Product Tech News

Hydraulic motors type MTK...HD series 2

New Series 2

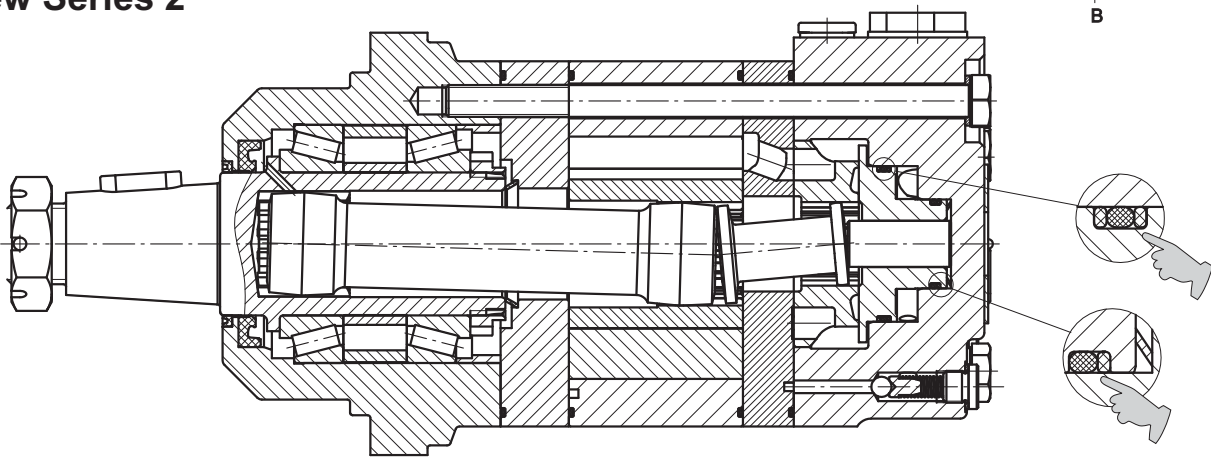
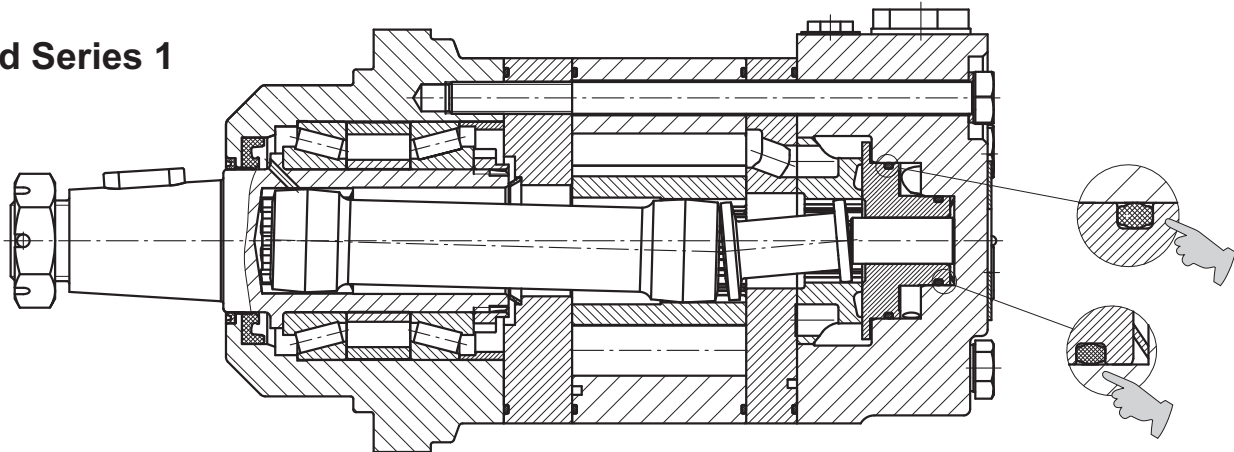
The reinforced MTK...HD series 2 motors deviate from MTK...HD series 1 on the following points:

1. In order to protect the O-ring during the high pressure peaks, the balance plate has been provided with a new seal construction.
2. A drain line should always be used in case of valve absence!
